MOTOR COACH
INDUSTRIES

SUBJECT: SAFETY RECALL OF DOGA WINDSHIELD WIPER MOTORS

Service Bulletin No. 344

<i>MODEL</i> E / J Series Coaches	<i>TYPE</i> Field Change Program	<i>SECTION/GROUP</i> 3-Body	<i>DATE</i> July 16, 2010
<i>SUBJECT</i> DOGA WINDSHIELD WIPER MOTOR			
<i>CONDITIONS</i>

Figure 2. Relay Installation

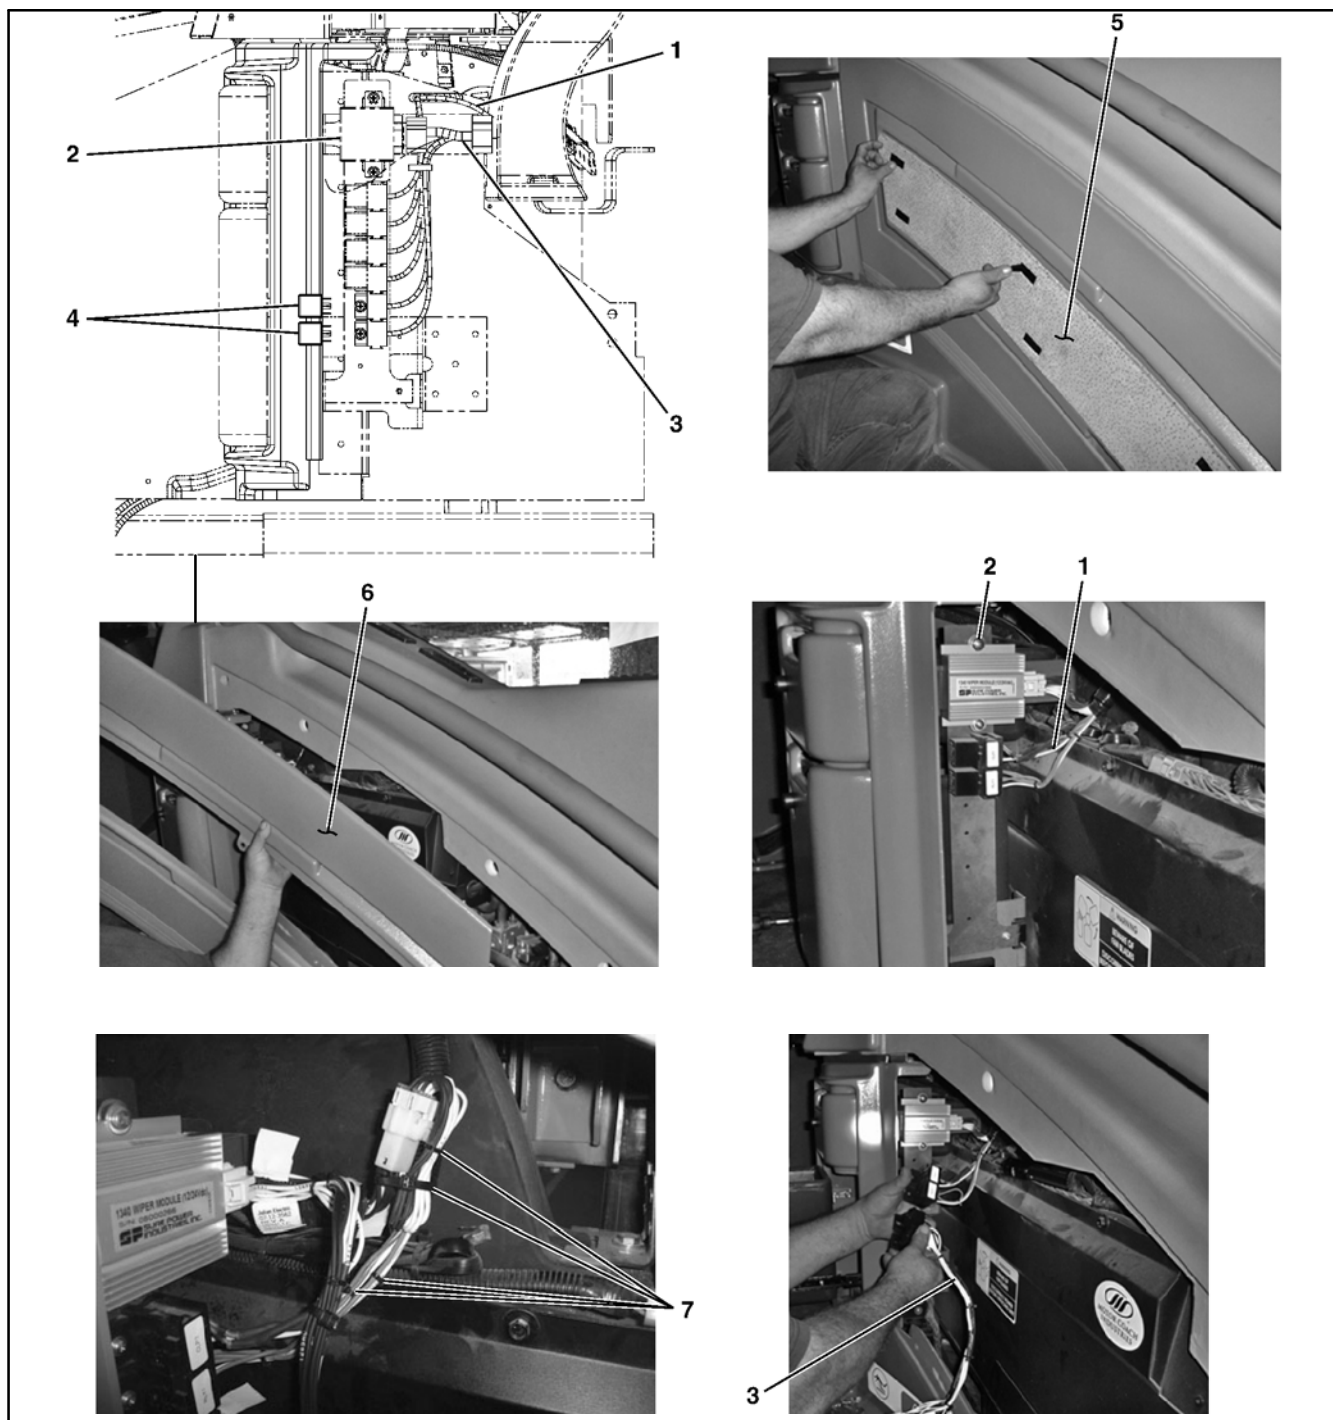
8. Remove the fabric return air panel and the return air panel as shown in Figure 2, items 5 and 6. Locate the wiper controller as well as dash harness Plug X145 (J1R) (refer to locations shown in Figure 2, items 1 and 2). Unplug Plug X145 (J1R) from the wiper controller.

9. Connect the male adapter P145B of the wiper controller adapter harness, p/n 07-12-3562, Figure 2, item #3, to Plug X145 (J1R) of the dash harness, Figure 2, item #1. Connect the female adapter P145A of the wiper controller adapter harness, Figure 2, item #3 to the wiper controller, Figure 2, item #2.55

10. Remove the relay bases of the dash harness and retain the hardware. Interlock the relay base located on the jumper harness with the existing relay bases (refer to Figure 2, item #4). Using the screw, p/n 19-1-696 and washer, p/n 19-2-7, install the relay base section of the wiper controller adapter harness, Figure 2, item #3. Install the two relays, p/n 7L-5-79, Figure 2, item #4 into the relay base.

11. Using tyraps, p/n 19-11-258, secure the wiper controller adapter harness to the dash harness as shown in Figure 2, item #7.
12. Using the hardware removed in Step 8, secure the fabric return air panel and the return air panel, Figure 2, items 5 and 6. Proceed to the outside of the coach.

Figure 6. Rear View of Wiper Motor Installation

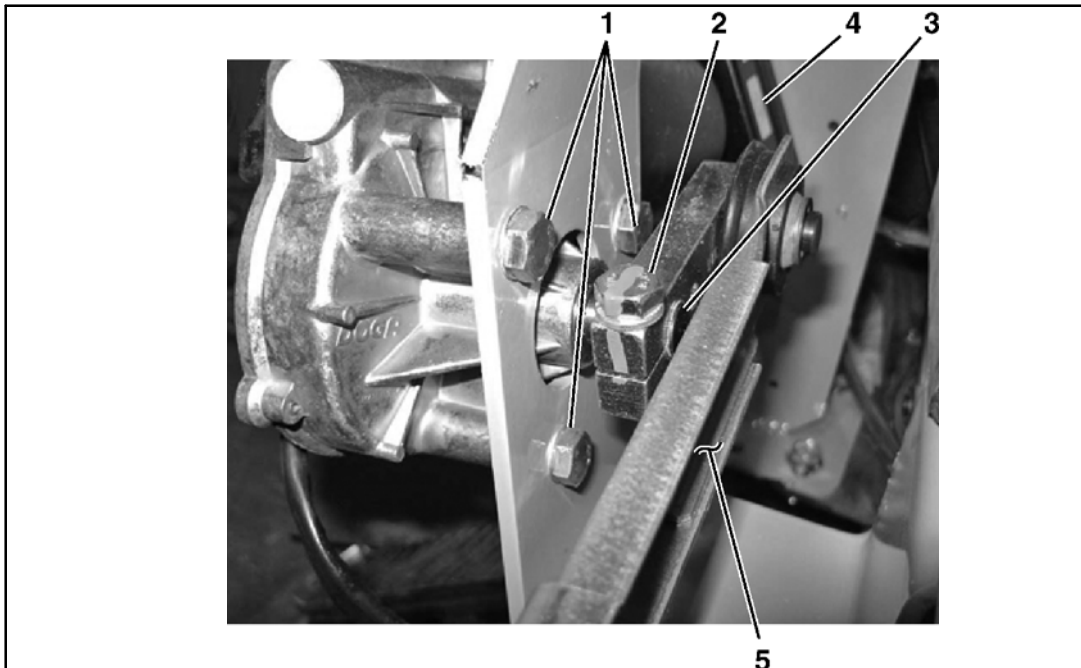
18. Locate the three wiper motor mounting bolts, Figure 6, item #1, securing the wiper motor to the bracket.
19. Loosen the wiper motor crank nut, Figure 6, item #2.
20. Carefully push the linkage off the wiper motor shaft, Figure 6, item #3, ensuring no damage to the splines.
21. Using a 1/2" wrench or socket, remove and retain the three wiper motor mounting bolts, Figure 6, item #1. Remove and discard the wiper motor.

28. Install the new wiper motor, p/n 03-34-1193, using the three wiper motor mounting bolts, Figure 6, item #1, removed in Step 21. Secure the wiper motor to the bracket. Torque the motor mounting bolts to 15 to 18 ft.-lb. Re-connect the wiper motor harness. Re-connect the the harnesses to the VIP controller, and , if applicable, the steer angle sensor (SAS) connector.

32. Align the wiper motor linkage, Figure 6, item #4, with the main wiper linkage, Figure 6, item #5, and mount it on the motor shaft. Torque the wiper motor crank nut, Figure 6, item #2, to 16 to 20 ft–lb. Apply torque seal from the face of the capscrew to the face of the wiper motor crank.

Figure 12. Bracket

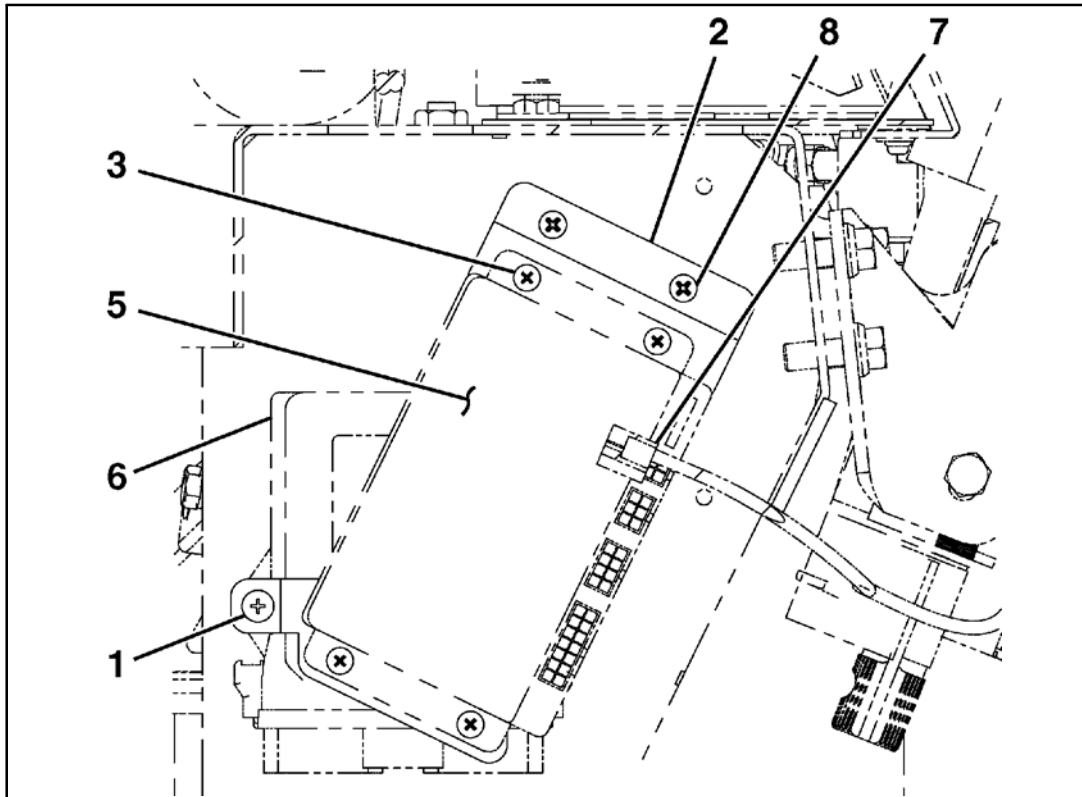
25. Locate the pocket gateway on the LH (roadside) of the steering column bracket (refer to Figure 10).
 Remove and discard the two mounting screws. Using screws, p/n 19-1-605, Figure 11, item #3 install the top and bottom brackets 07-08-3730 and 07-08-3732, Figure 11, items 1 and 2, to the VIP.

26. Mount the VIP and bracket assembly to the existing pocket gateway mounting holes using 19-1-583 screws for the bottom bracket, mount the top bracket with p/n 19-1-696, screws, refer to Figure 12, items 1, 2 and 5.

27. Cut to length and install trimlock, p/n 21-7201-10, on bracket edge as shown in Figure 12, item #4.

Figure 13. Wiper Arms Before and After Linkage Adjustment

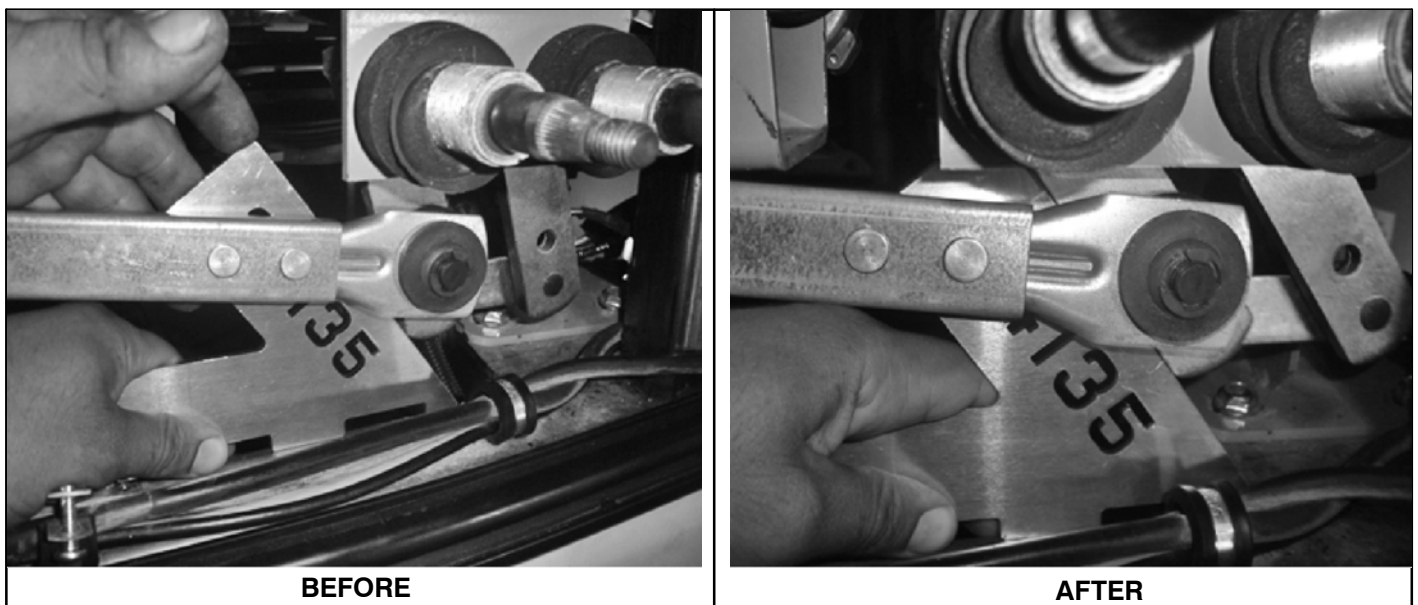
33. Positioned in front of the coach, locate the main wiper linkages (refer to Figure 13).
34. Verify that the arm swing angle from the wiper arm pivot is 35 degrees on both sides vertical by utilizing a gauge. With gauge tool 24135 Ensure the angle measured from the frame member is 55 (+/- 1.0) degrees (refer to Figure 13 and gauge tool 24135 template included with this procedure and kit). Repeat on opposite side of coach.

If the angle measured from the frame member is not 55 (+/- 1.0) degrees on both the curbside and roadside wiper arms as shown in Figure 13, proceed to Step 35.

If the angle measured from the frame member is 55 (+/- 1.0) degrees on both the curbside and roadside wiper arms as shown in Figure 13, proceed to Step 36.

35. Locate the wiper arm linkage sliding channel. Loosen the bolts on the sliding channel and adjust the linkage to achieve the 55 degree angle. Tighten bolts. Using the gauge, ensure the linkage is 55 degrees. Torque bolts to 16–18 ft–lb.

Figure 14. RH Under-Dash Kickpanel

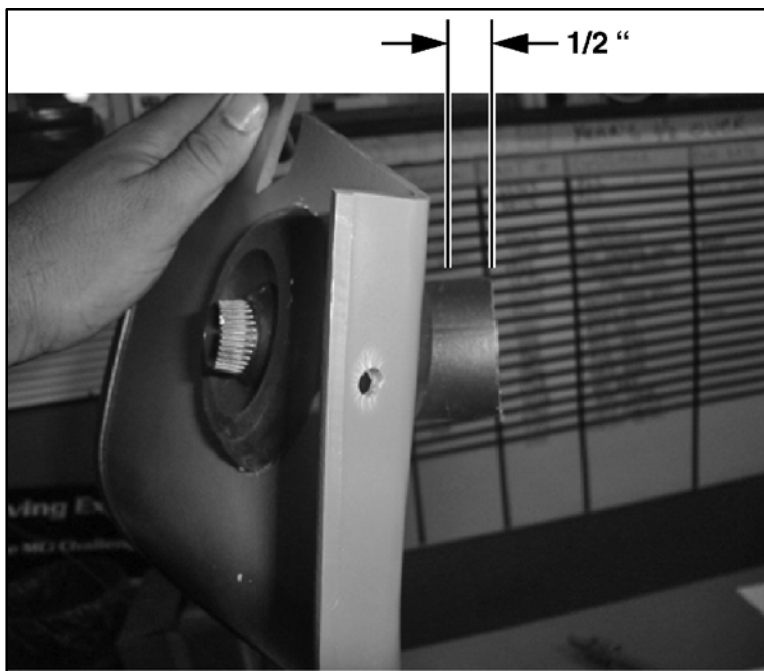
37. Re-install the wiper arms.
38. Re-connect the washer fluid supply lines to the wiper arms.
39. Position the ENGINE RUN and ENGINE START switches on the engine compartment remote control box to the ON position. Close the engine door.
40. Test the wiper system by operating the wiper system in low, intermittent, and high speed modes for several cycles of the wiper. Ensure the wiper stops in the "parked position" when the "Smart Stick" rotary position is at OFF. Adjust as necessary.
41. Before installing the RH under-dash kickpanel cut 1/2" from the straight part of the gasper assembly (refer to Figure 14).

Figure 16. Post-retrofit schematic.

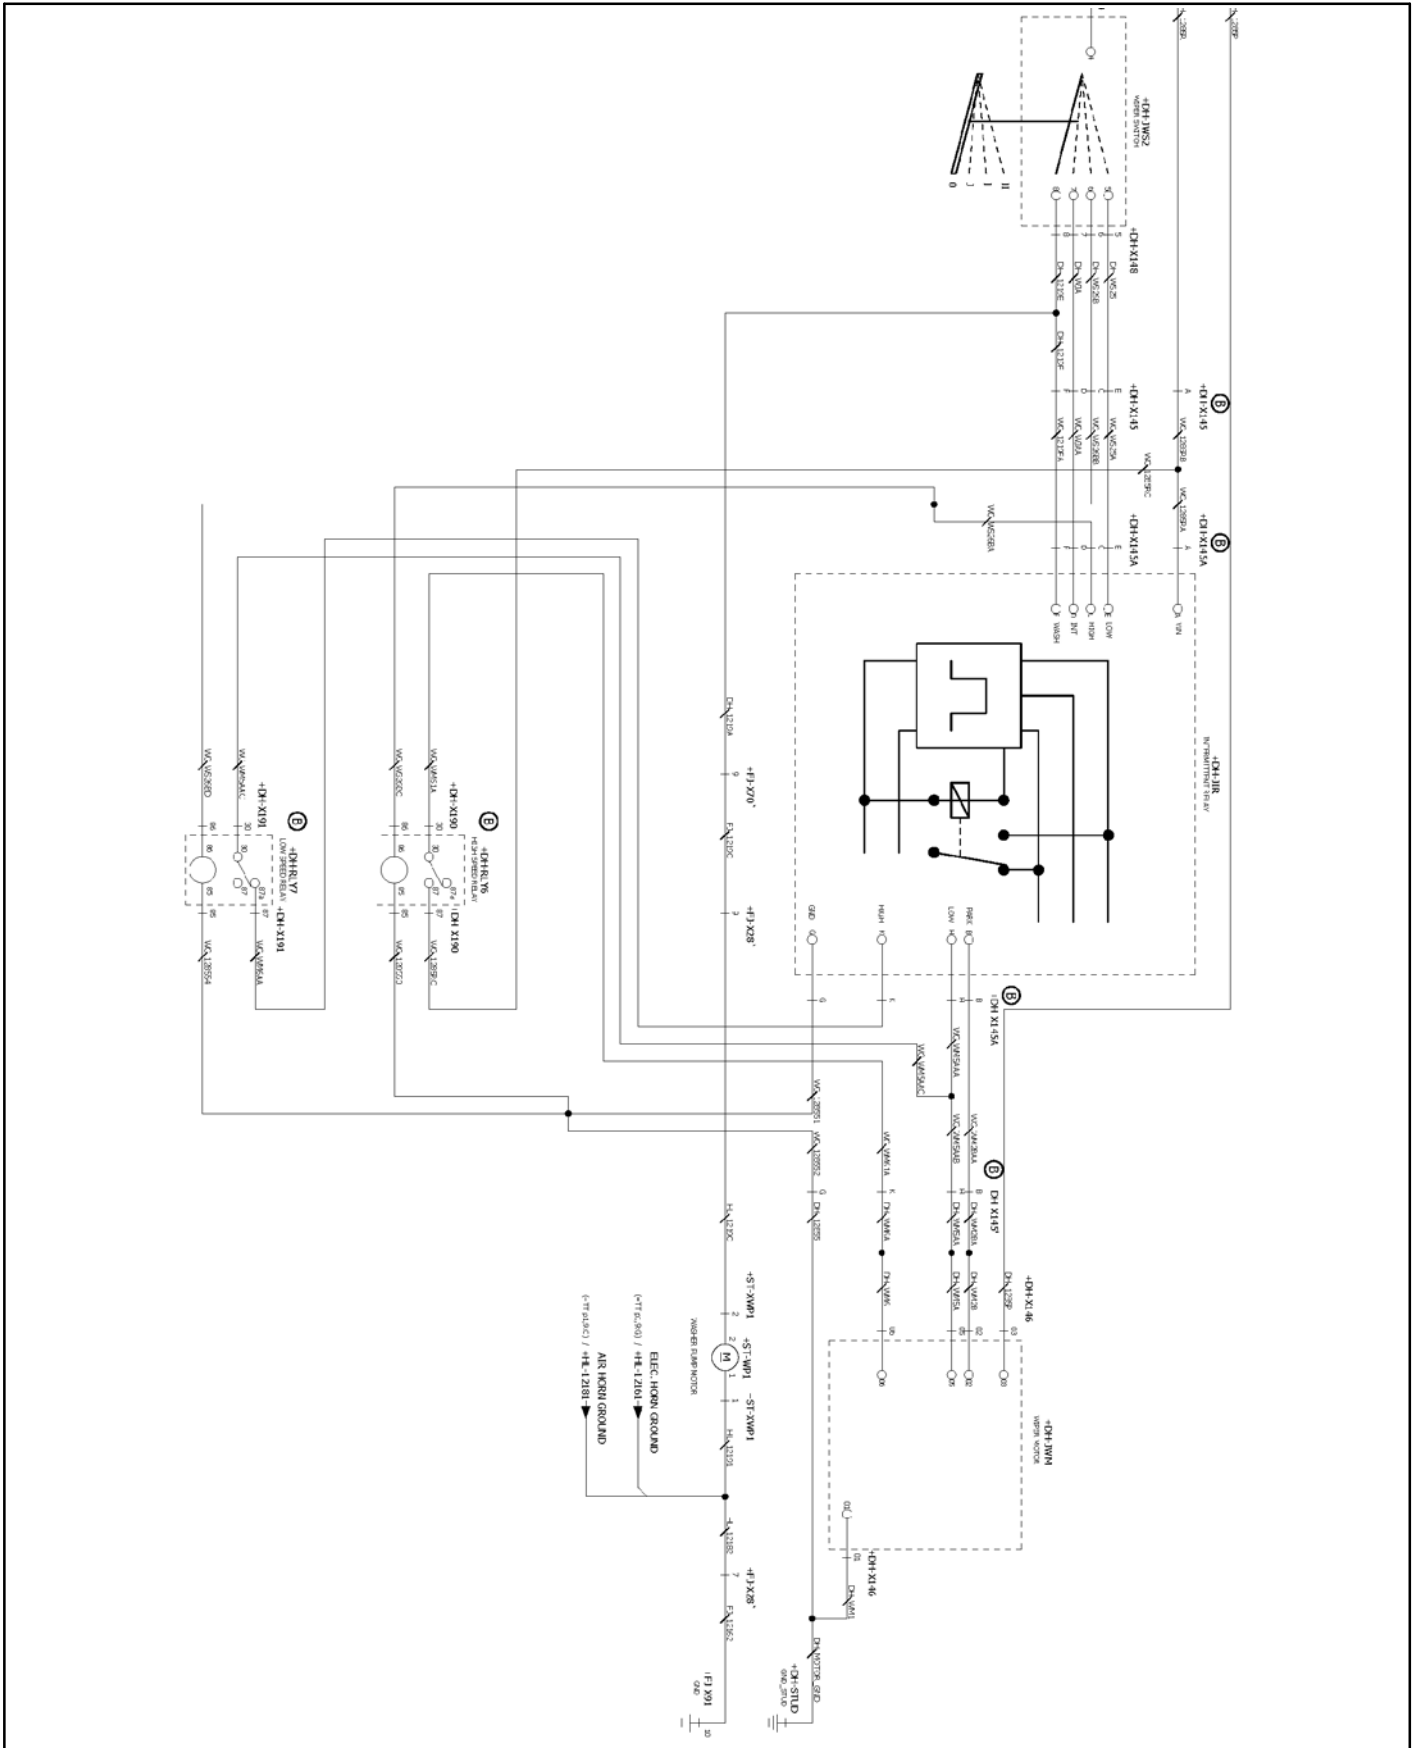
MCI strongly encourages customers to install a new DOGA model 259 motor in place of the existing model 258 motor. The 259 motor has a higher load capacity than the current 258 motor, which is intended to provide an additional safety margin to the wiper system. In addition, the installation of a bypass harness on the controller will prevent the controller from switching the motor to high speed.
